**Project:** Richmond Rd M7 Motorway to Townson Road

**Phase:** Substantial Detailed Design (Review 2 of 2)

**Package:** Culverts

**Date of Issue:** 29 May 2026

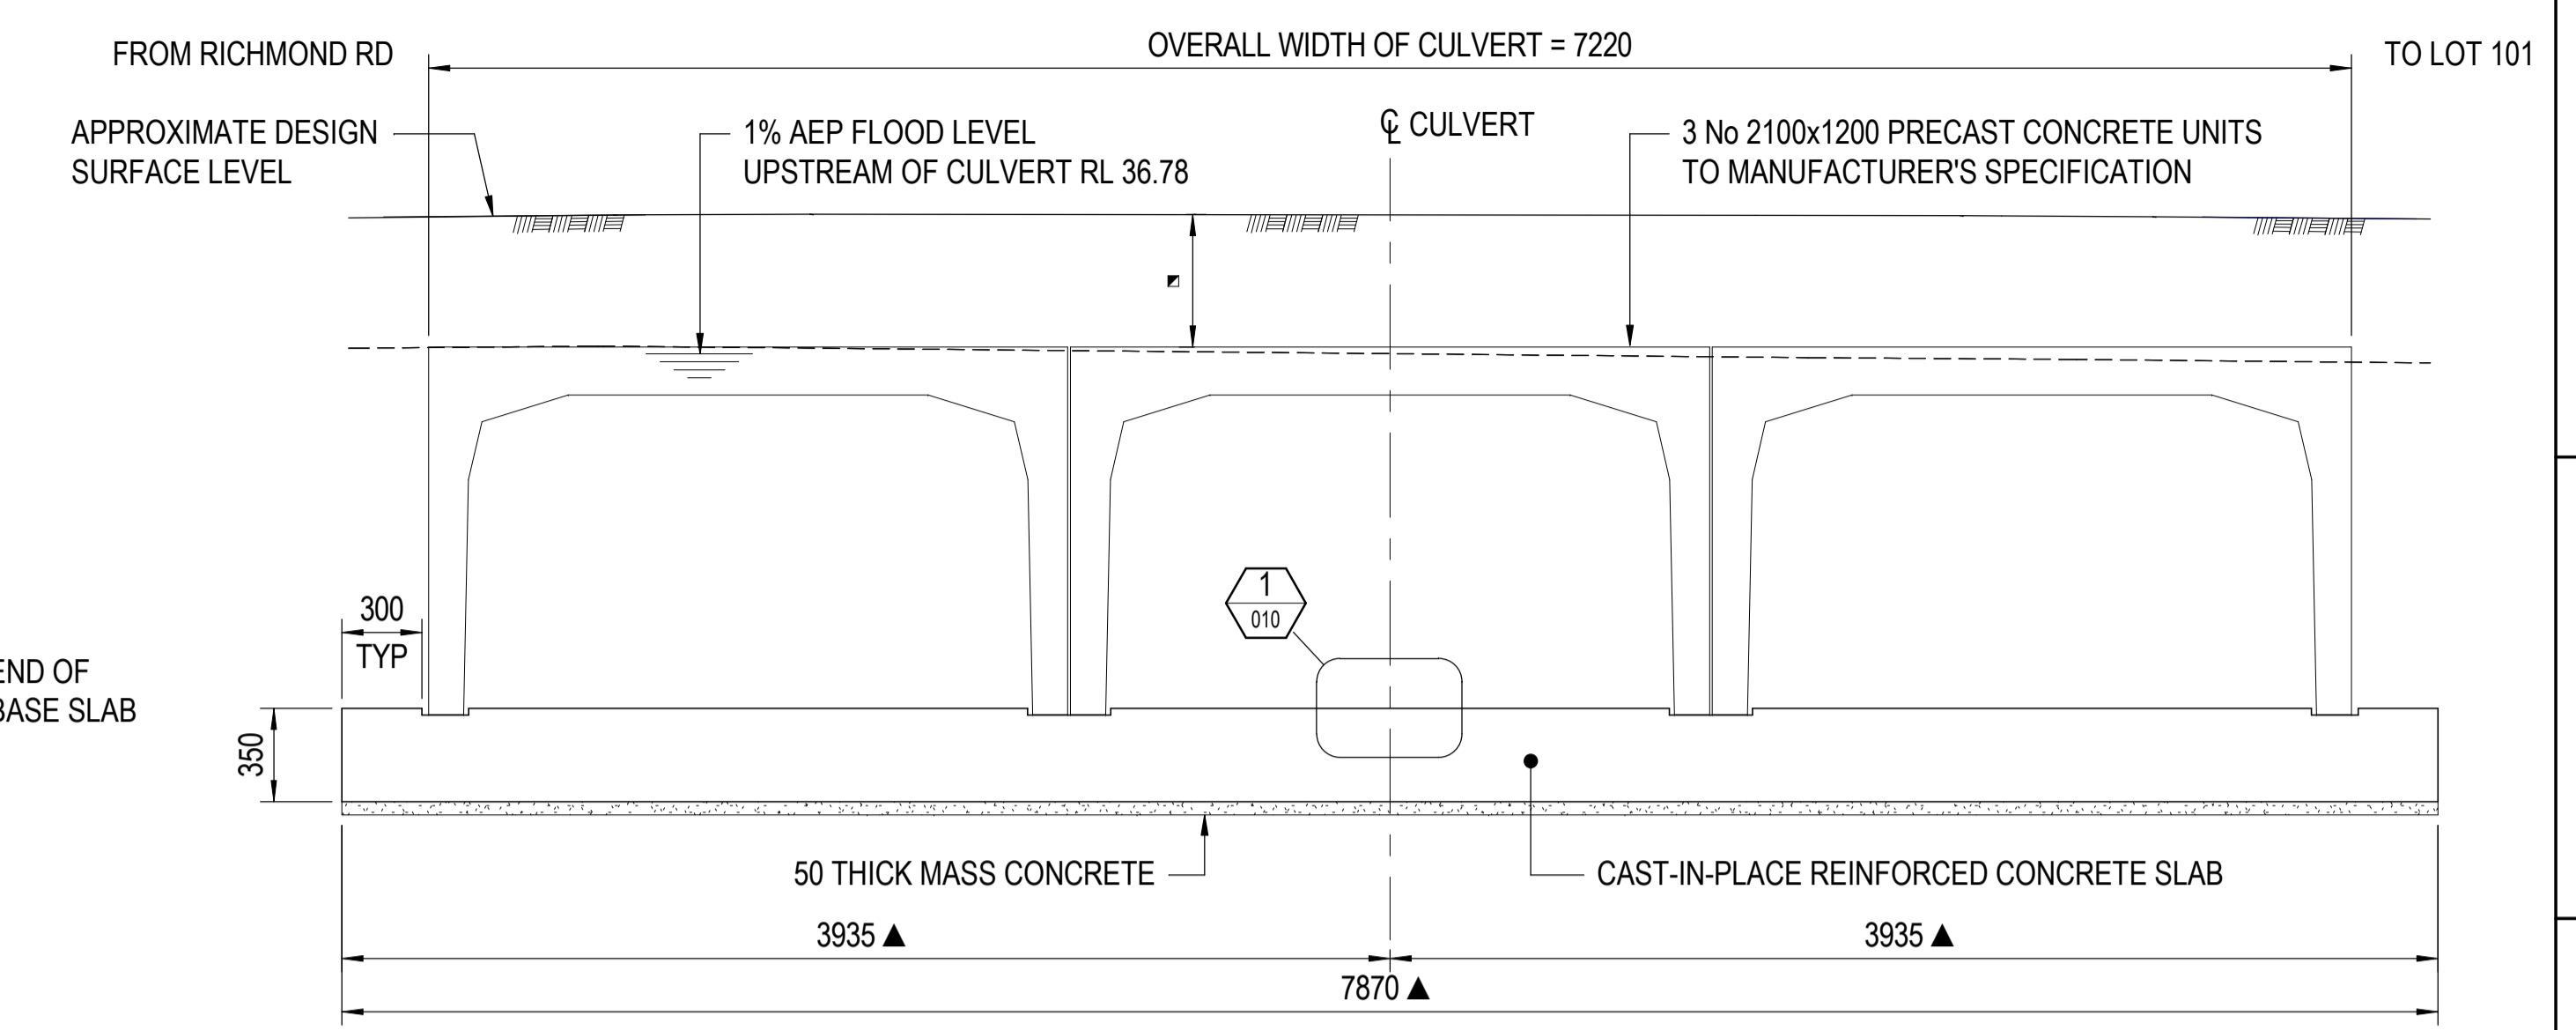
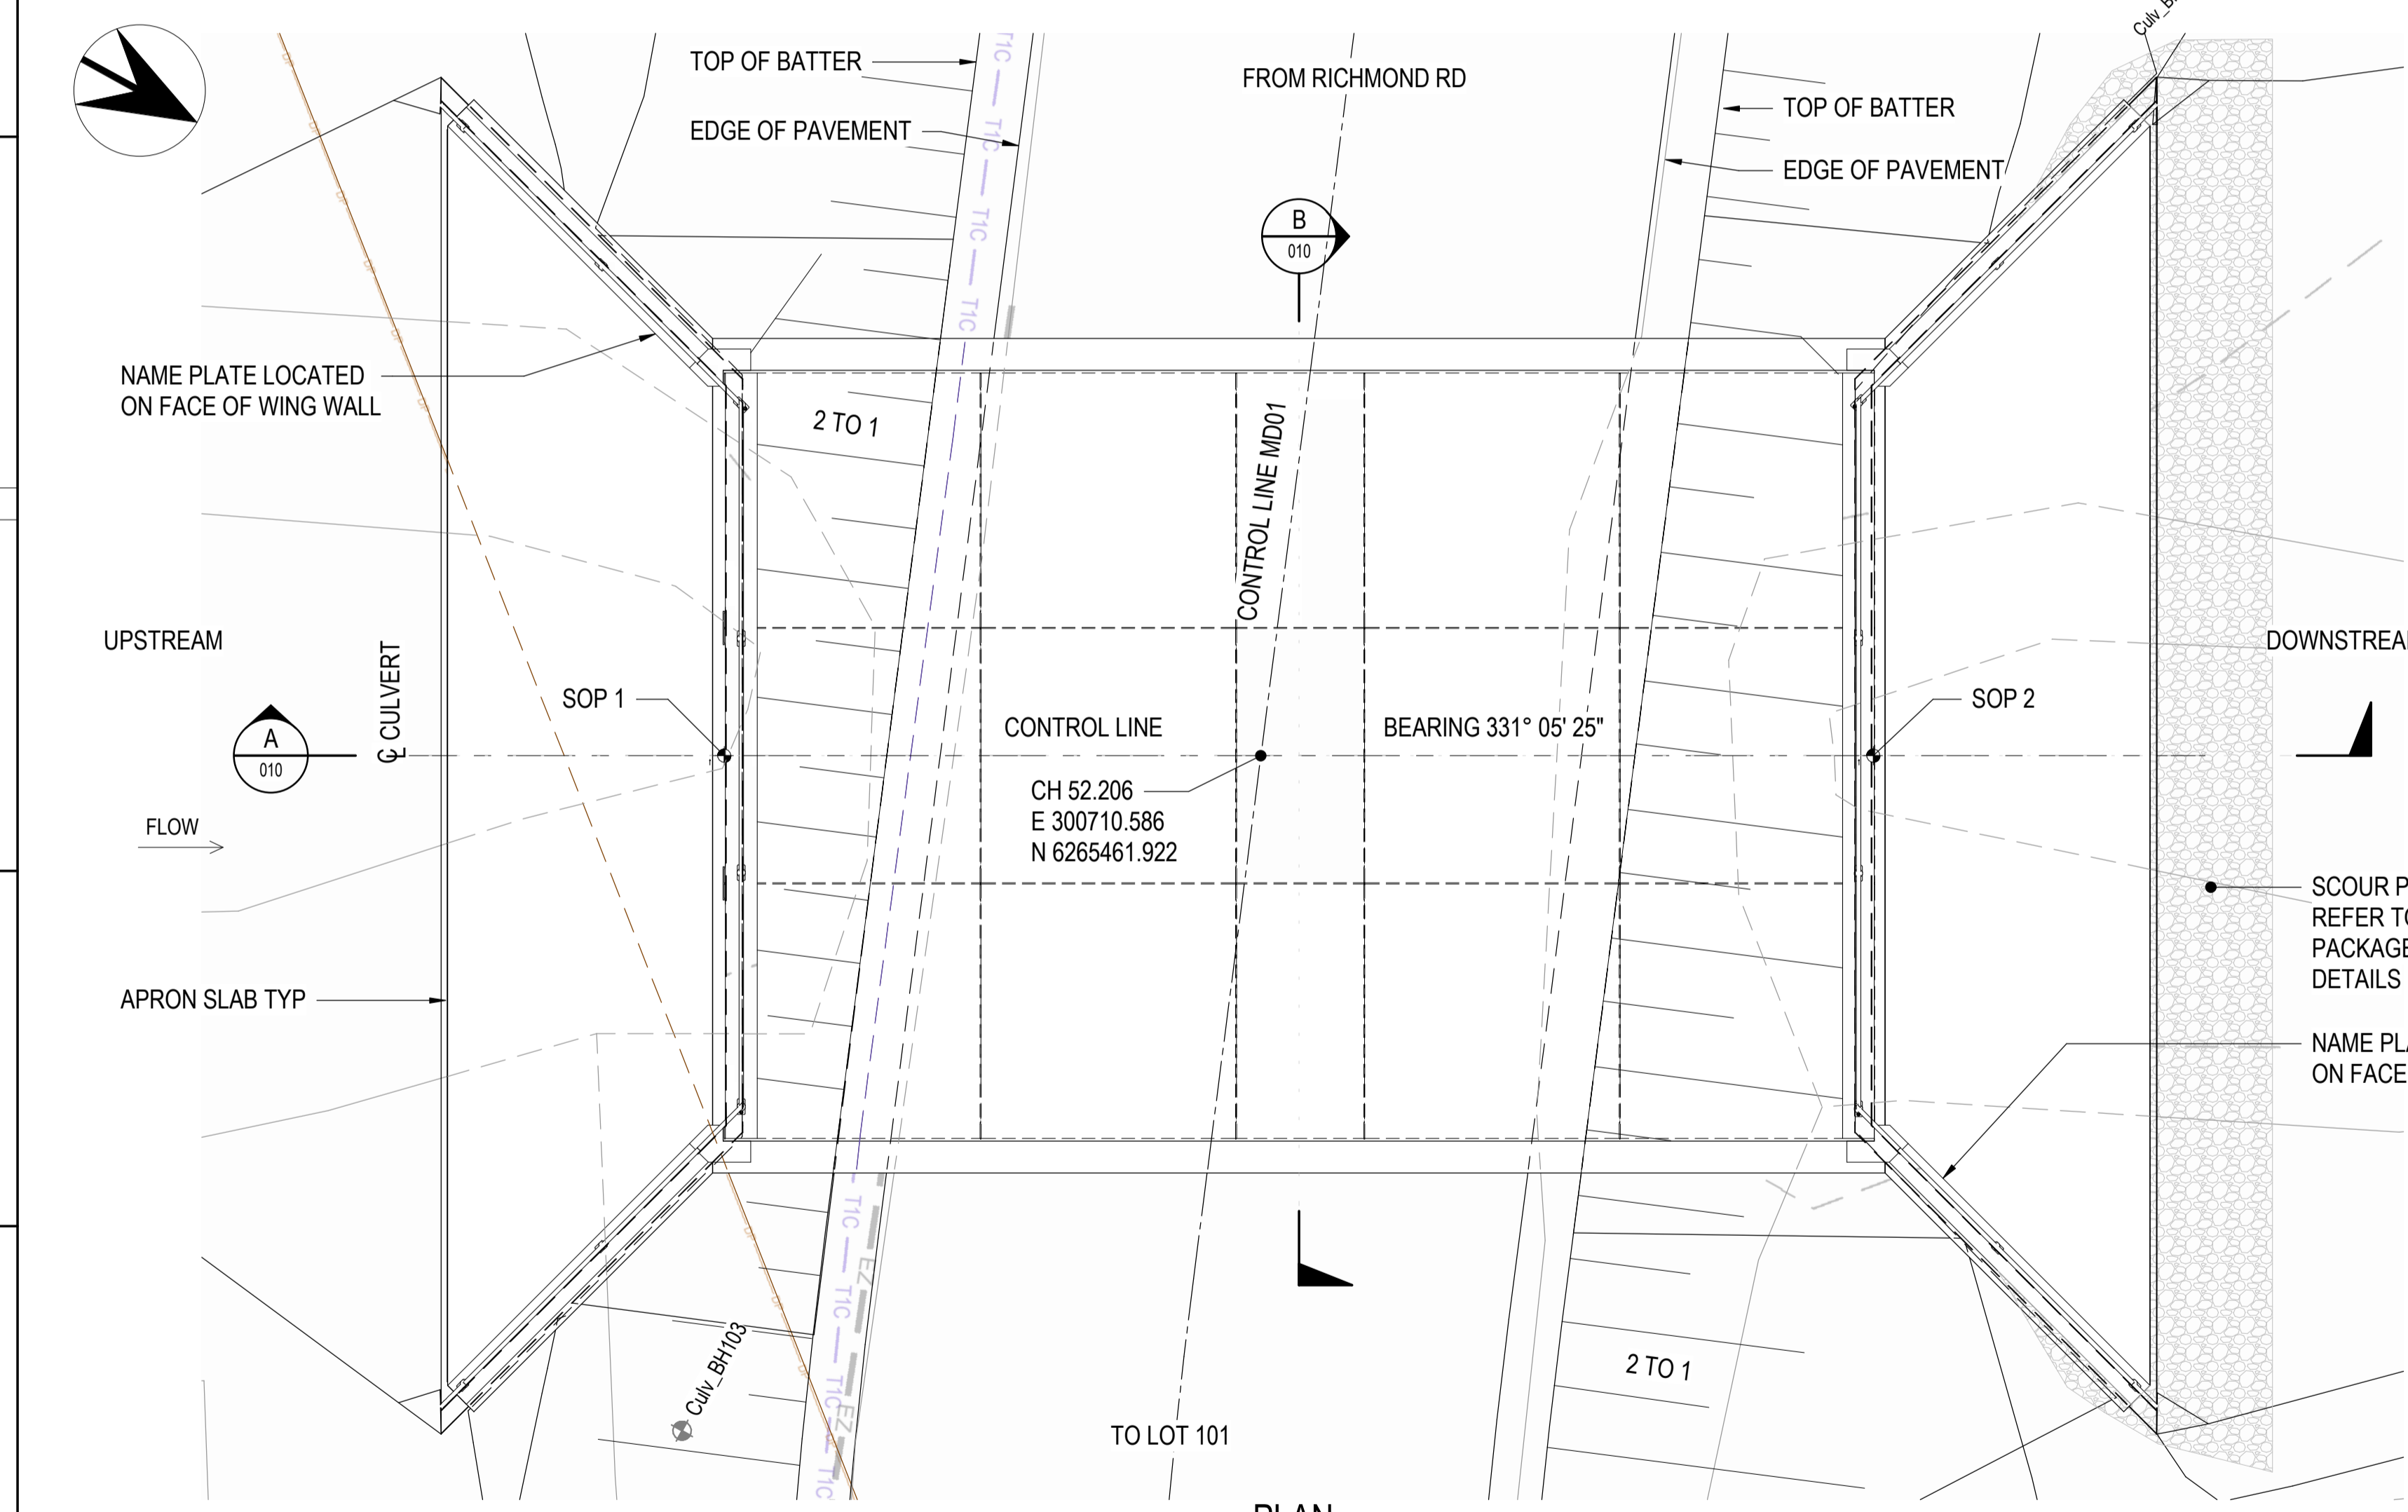
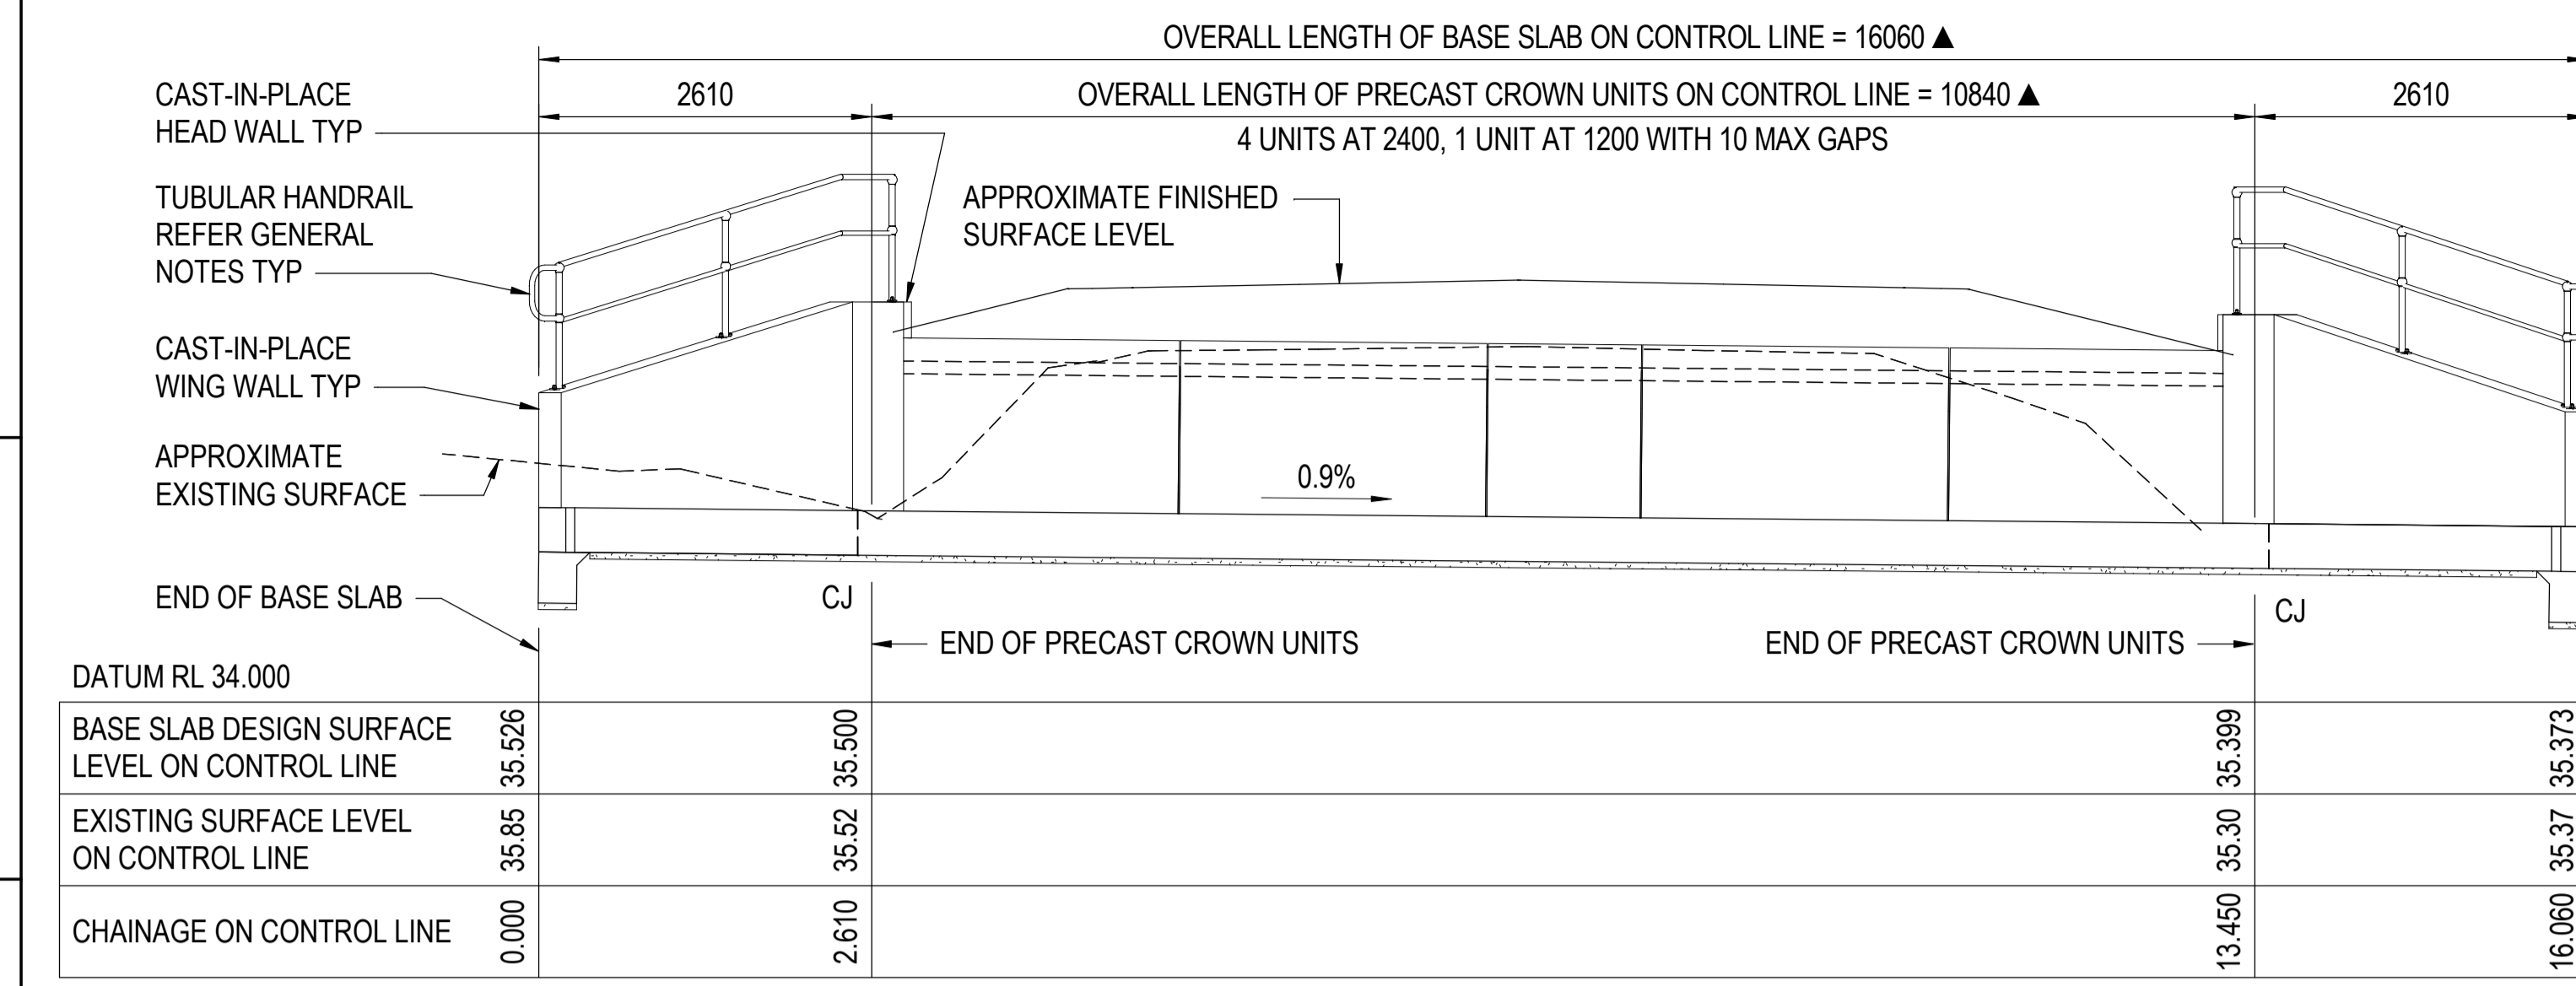
The overall footprint of this culvert structure has not changed, however the cells have increased in height from 900mm to 1200mm. This increase in height is being accommodated by a higher surface at road level (the bottom slab has not gotten any deeper)
